Product/Process Change Notice (PCN)

PCN #: PCN_IndTFCH_20140321

Product Affected: WE-TFCH series

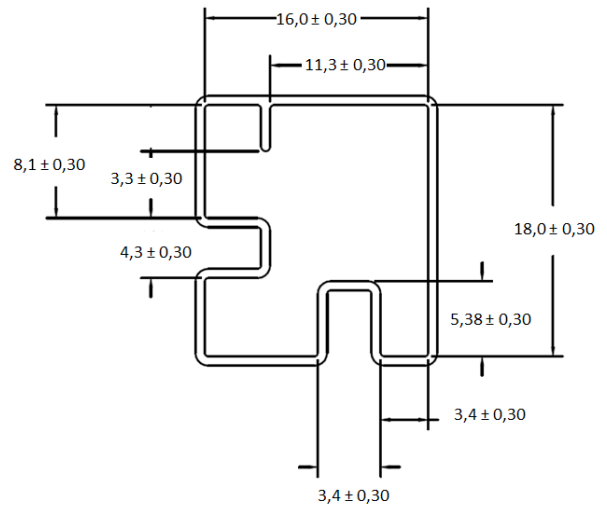
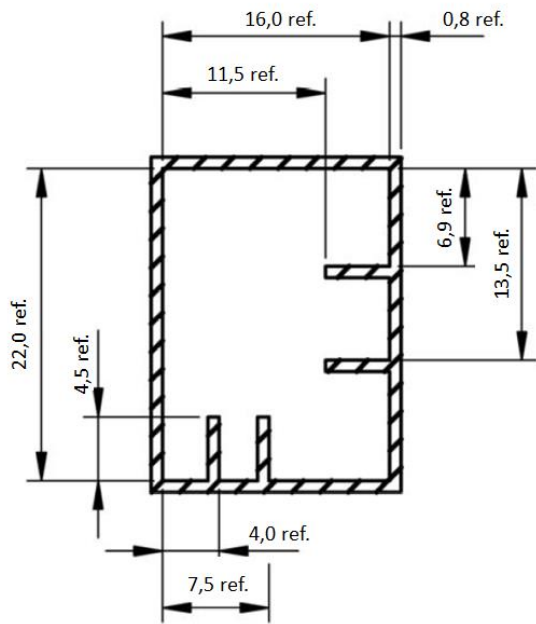
1. To ensure and improve the quality and stability of the component, the production line will be changed.
2. The following packaging improvement will be implemented: The tube shape will change to prevent the components to get caught each other inside the tube. Foam rubber stoppers will be included in the ending of the tubes to prevent the components to move.
3. Varnish glue will be implemented during production process to improve the fixation of the core.
4. Electrical and mechanical properties of the component will not be affected by the change.

OLD – Some glue dots to keep the core pieces together.

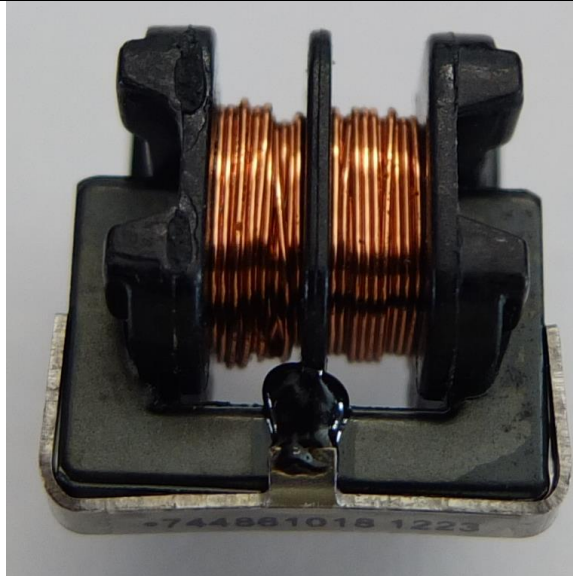
As shown in the last set of images, a replacement of the glue implementation technique will be done. With the new glue implementation the components have no glue dots. Varnish glue will replace the function of this glue dots.
